Possible Action on Contract Amendment with TSW for South Canton Park

CONTRACT AMENDMENT 1

Design Services for **South Canton Park** (the "PROJECT")

Exhibit A

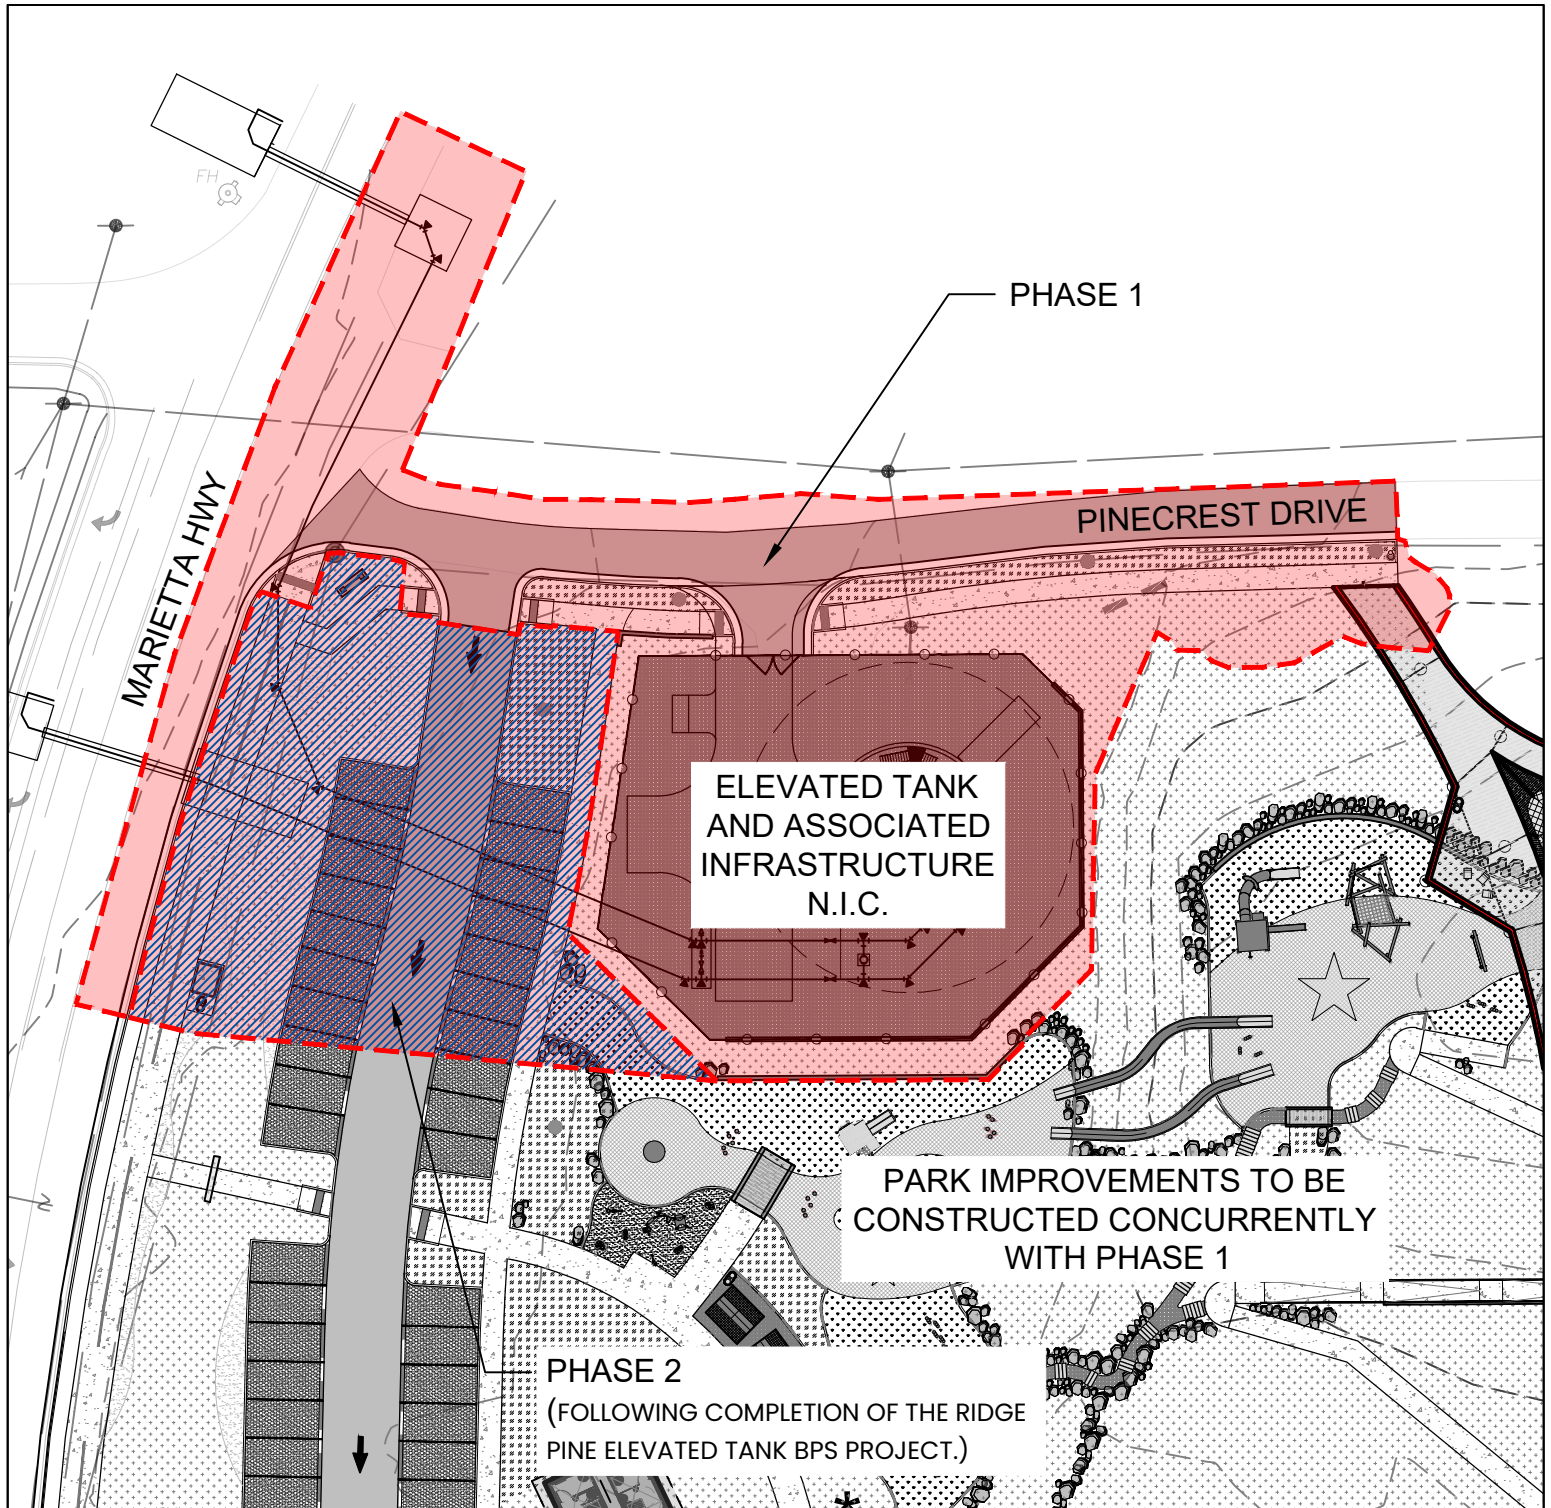
As outlined in Exhibit 'A' – Phase 1 will include the construction of the site improvements outlined above and the Ridge Pine Elevated Tank BPS project. Park construction is intended to run concurrently with these Phase 1 improvements. Phase 2 will include completion of the Park site improvements in the Elevated Tank lay-down area following completion of the Ridge Pine Elevated Tank BPS project.
